City of Detroit
Inter-Departmental Communication

RE: Petition No. 1318
Requested Encroachment into Park Ave. Bagley, and Washington Blvd.
at 313 Park Ave. with Planters, Café Seating, Awnings, Retail Displays,
Stairs and Landscaping

NOTICE OF PROPOSED CHANGE IN PROPERTY

PROVISIONS FOR ENCROACHMENT For Petition 1318

CITY OF DETROIT CITY ENGINEERING DEPARTMENT SURVEY BUREAU	
JOB NO.	01-01
DRWG. NO.	X 1318

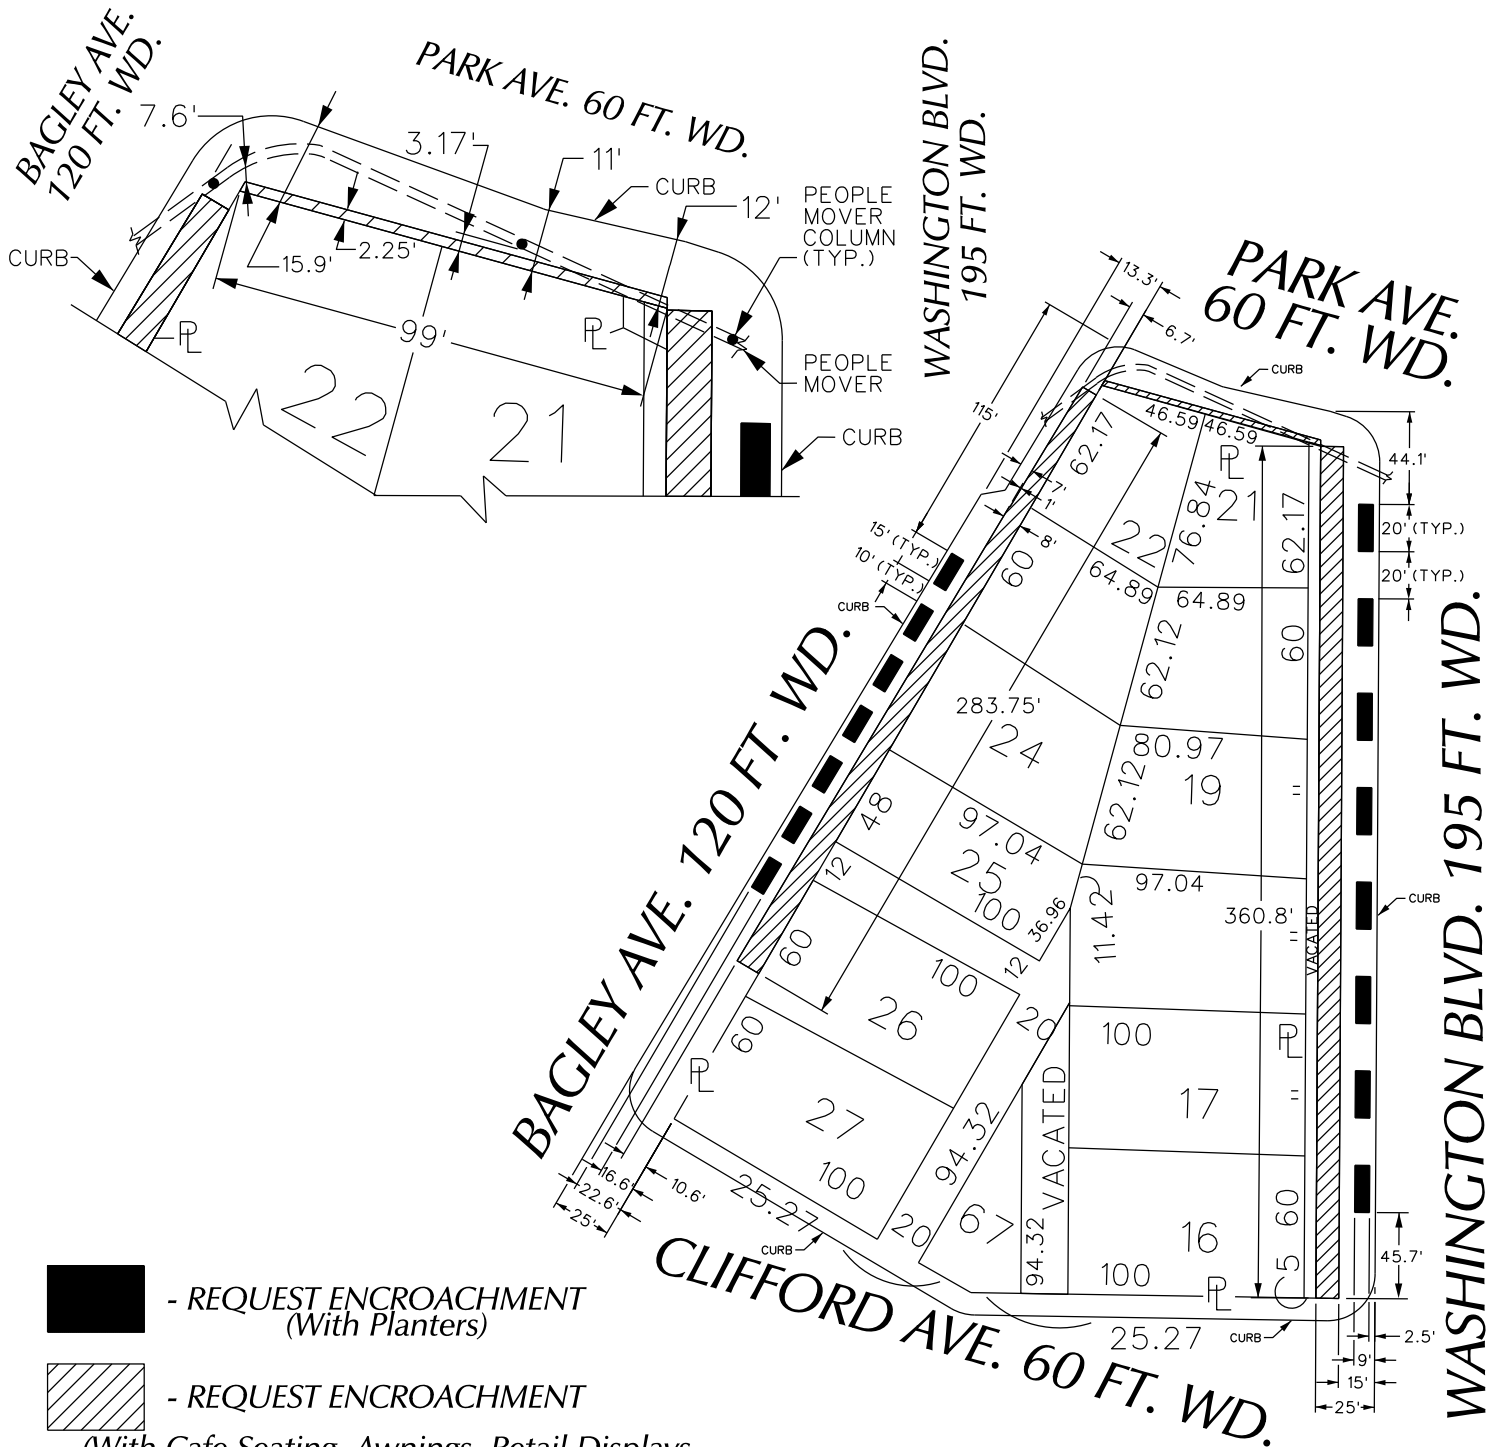
- DWSD has no objection to the requested encroachment provided that the attached Provisions for Encroachment are strictly followed.
